Product Change Notice

Issue Date: 30th August 2010

Please be informed that Avago Technologies is making the following product changes on 0.28" (7.0mm) surface mount LED display listed below:

1. Carrier tape type

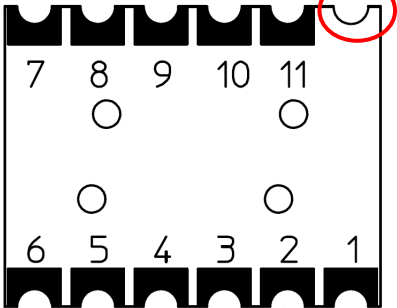
Change carrier tape type from black carrier tape to clear carrier tape as shown below:-

New	Current
0.28" Single Digit		
0.28" Dual Digits

For orientation and inspection checking purposes.
